## **REMARKS**

This amendment is provided in response to the Office Action of Nov. 22, 2004. In view of the above amendments, and the following remarks, applicants respectfully request reconsideration of all grounds for objection in this matter.

Appl. No. 10/707,951 Amdt. Dated Jan. 4, 2005 Reply to Office Action of Nov. 22, 2004

FIG. 3A

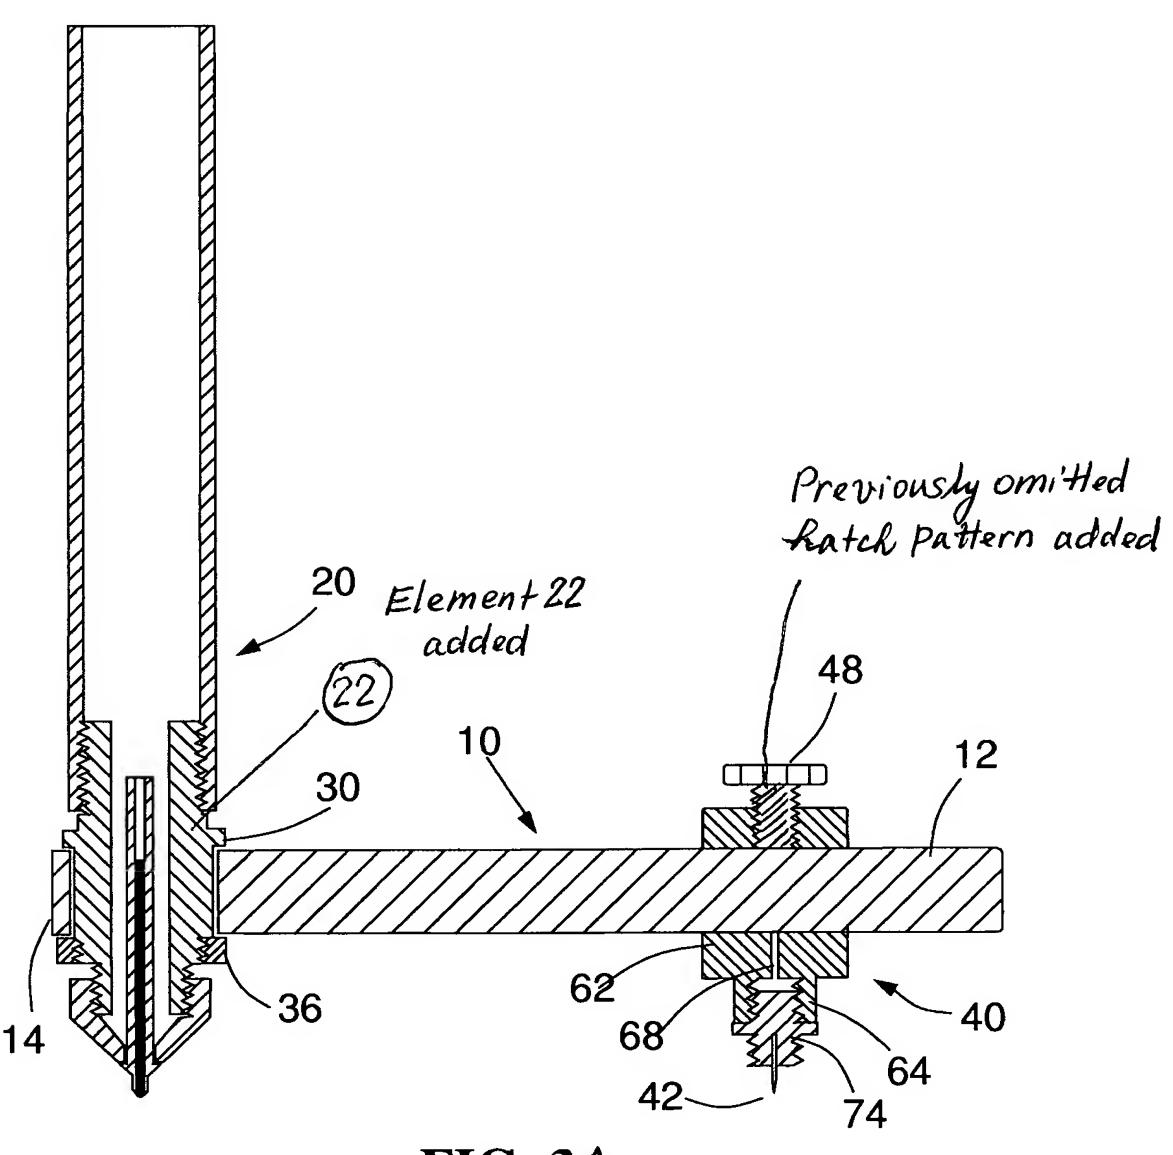
The Office Action objected drawings under 37 CFR 1.83(a) since it was said that the drawings must show every feature of the invention specified in the claims. Therefore, the ball bearing of claim 8, the roller bearing of claim 9, and the inclination of the handle or the pressing to obtain the inclination in either of claims 10 or 20 must be shown or the feature(s) canceled from the

FIG. 3 has been replaced by FIG. 3A where a previously omitted element 22 has been added and

a minor error in element 48 has been corrected.

The attached sheet of drawings, which includes FIG. 3A, FIG. 3B and FIG. 3C, replaces the

original sheet including FIG. 3.

FIG. 3 becomes FIG. 3A.
